Service Bulletin 70

Vertical fin cracks

All Sportsman aircraft

Model: Sportsman	Document: Service Bulletin 70	Revision: -	Date: 4/16/2013	Page: 1
---	---------------------	-------------------------------------	----------------	--------------------	------------

Required Action:

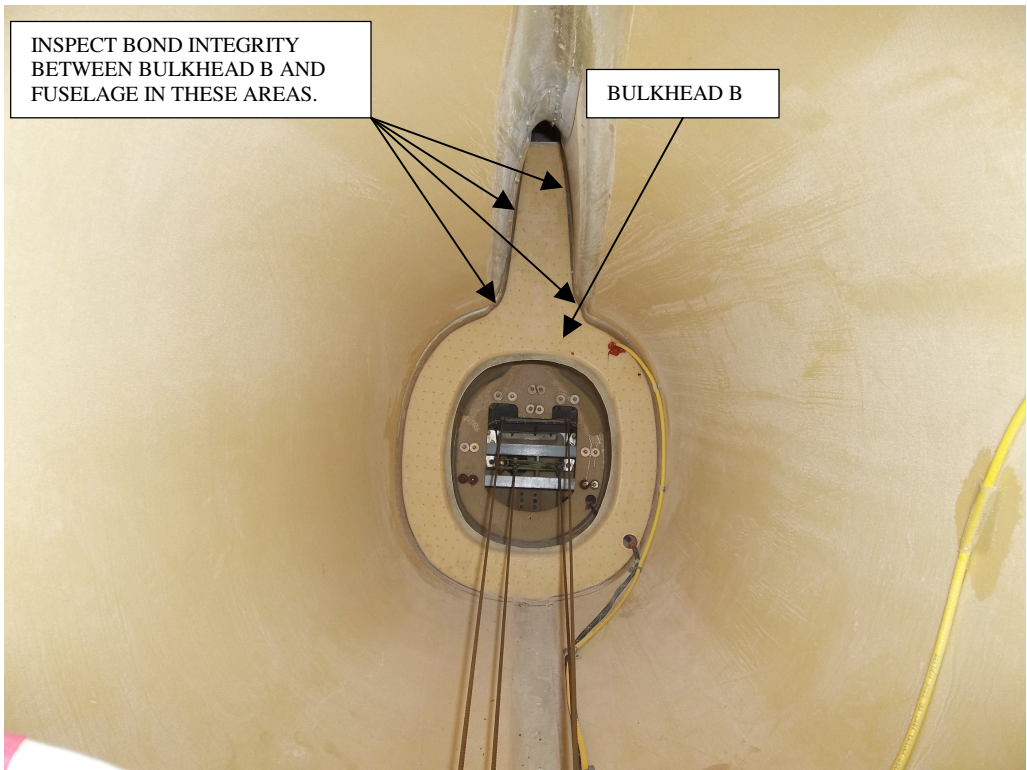
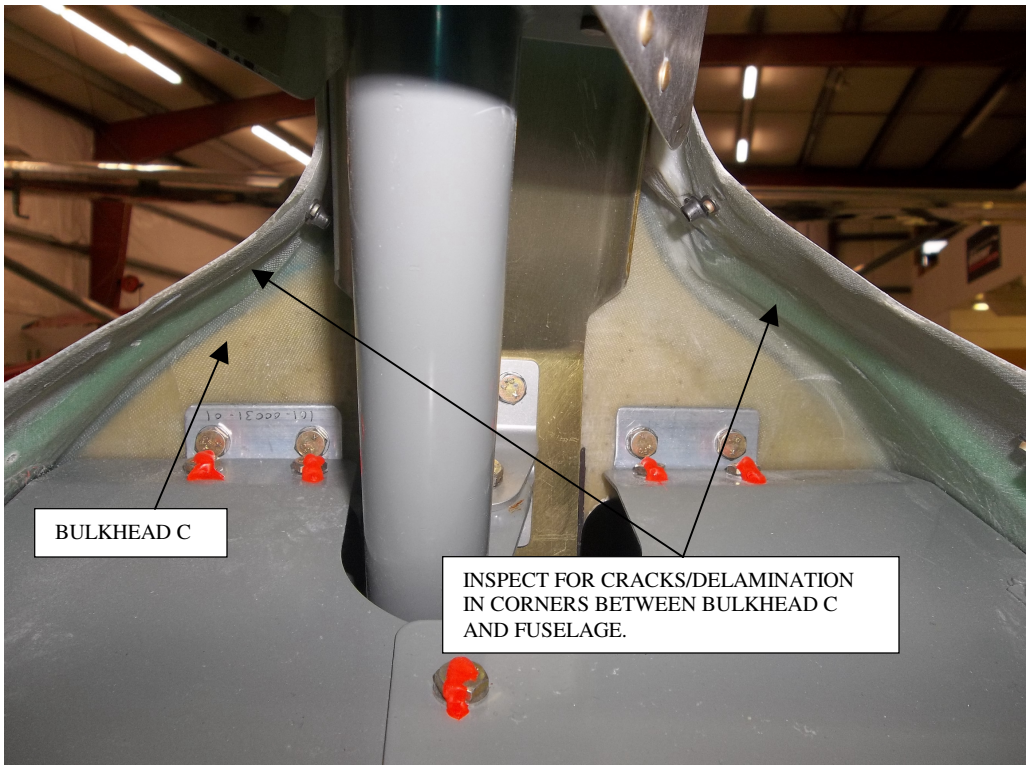
- 1) An inspection is to be completed prior to the next flight.
- 2) Repairs to interior cracks and separation are to be completed as outlined below prior to the next flight.
- 3) Reinforcement of the attachment of the vertical fin spar to bulkhead C with part # 101-00019-01 should be completed after all composite repairs are accomplished. Installation should be completed prior to or during the next annual inspection.

Note: we found that while repairs to the existing structure are important, the reinforcement doubler by far is the most significant component to prevent future cracking issues in this area.

REPAIRS:

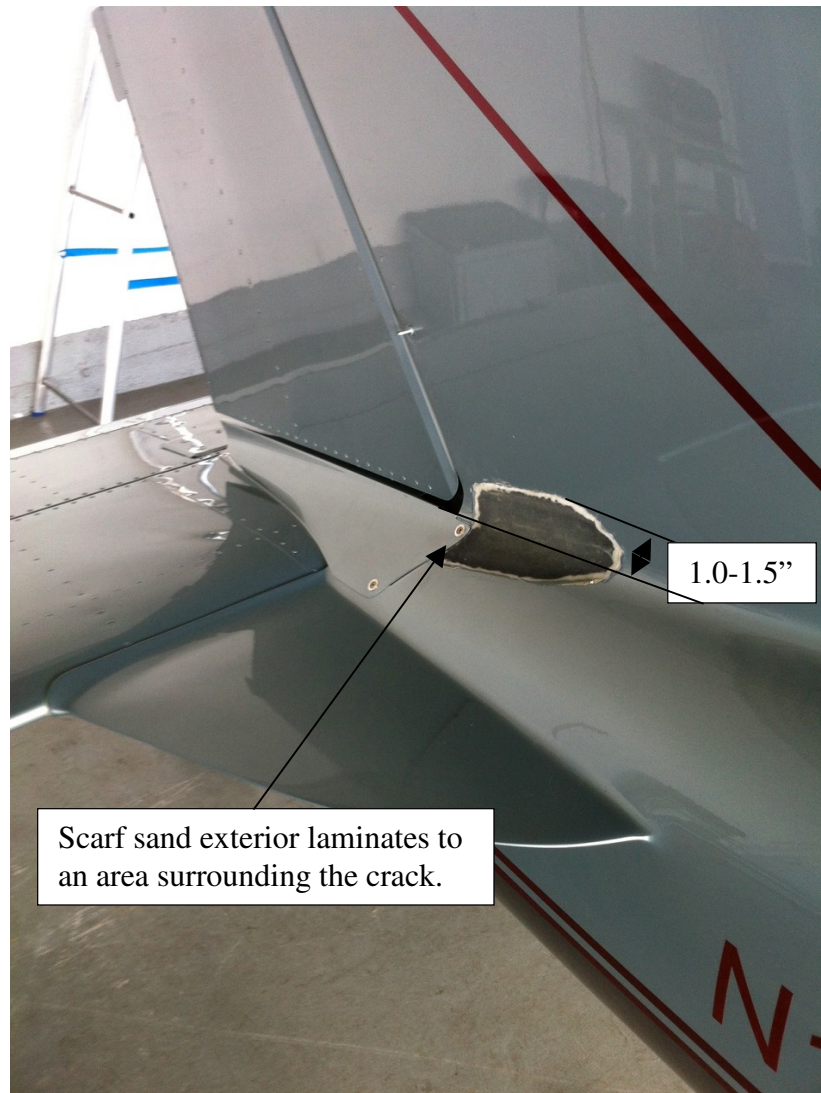
External cracks: Sand through the paint and filler in the areas of external cracks to determine if the cracks are deep enough to be in the laminates. If so, scarf (taper) sand the external laminates down to a level where the cracks disappear (do not exceed a depth of 1/16" deep). The taper-sanded area should extend approximately 1.0-1.5" beyond the crack. Cut some plies of 7781 fiberglass cloth on a 45 degree bias to fill the area sanded. You will need to use 2 or 3 plies depending on the depth of your scarf joint at the deepest point. The pieces of cloth will need to increase in size from approximately 1.0" wide to 2.0" wide so that the edges do not stack directly on top of each other.

Clean the area with acetone and laminate the cloth layers in place followed by a piece of peel ply. (Do not add extra resin with the peel ply. Wipe any excess resin from the brush and allow

resin from the laminates to saturate the peel ply.) Once the resin has fully cured, remove the peel ply and prepare the surface for paint.

FILE NO. 00019-01 LOCATION 101	DRAWN BY: KEVR APPROVAL DATE: 02/19/13 DATE: SIZE A	SCALE: NONE DWG NO. 101-00019 USED ON: SHT. 1 of 2

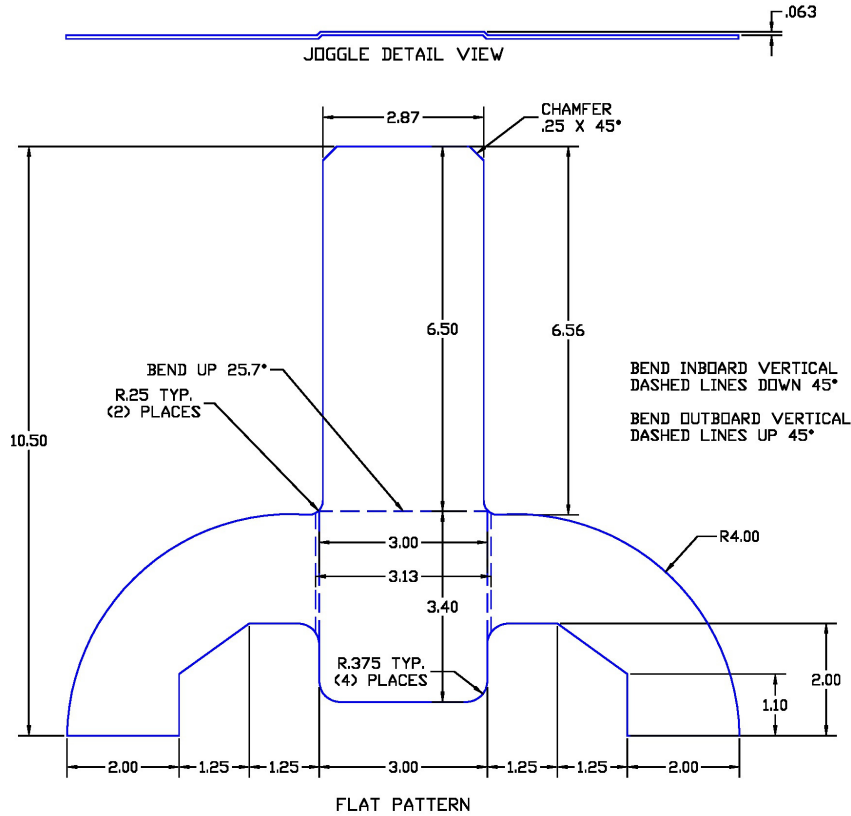
To add an extra degree of stiffness to the attachment of the vertical fin spar to bulkhead C for prevention of future cracking, an aluminum doubler (shaped like an inverted sling-shot) is placed beneath the lower rudder hinge flush against the spar and bulkhead. It is fastened with AAPQ-42 pull rivets to the vertical fin spar. It uses the four AN-3 rudder hinge bolts and forward shearweb bracket bolts to tie the doubler to bulkhead C as well as additional AAPQ-42 rivets. A part drawing has been included for reference, should you wish to fabricate the part yourself. The part will also be available for purchase from Glasair Aviation; contact customer service by phone (360-435-8533 EXT. 232) or email (harry.delong@glasairaviation.com) for details.

Note: Locating the holes in the doubler for the rudder hinge and shearweb brackets can be a bit tricky, as this task needs to be accomplished without enlarging the existing holes or drilling them crooked. After positioning the bracket and drilling/clecoing it to the base of the vertical fin spar and bulkhead C, take a cordless drill into the aft fuselage with a new, sharp #10 bit and pass drill through the reinforcement doubler through the four existing holes used to attach the lower rudder hinge fitting. It is imperative that the holes be drilled straight and perpendicular to the face of bulkhead C in order for them to match up to the rudder hinge pattern. As a minimum, drill two opposing corner holes from inside the fuselage; bolt the hinge in place, then drill the opposite holes using the hinge as a guide.

The result of adding the .063” thick doubler beneath the hinge and brackets will be to shift the rudder and shearweb brackets back by 1/16”. Simply file the holes in the forward shearweb oblong by this amount to accommodate alignment of the bolts to the nutplates.
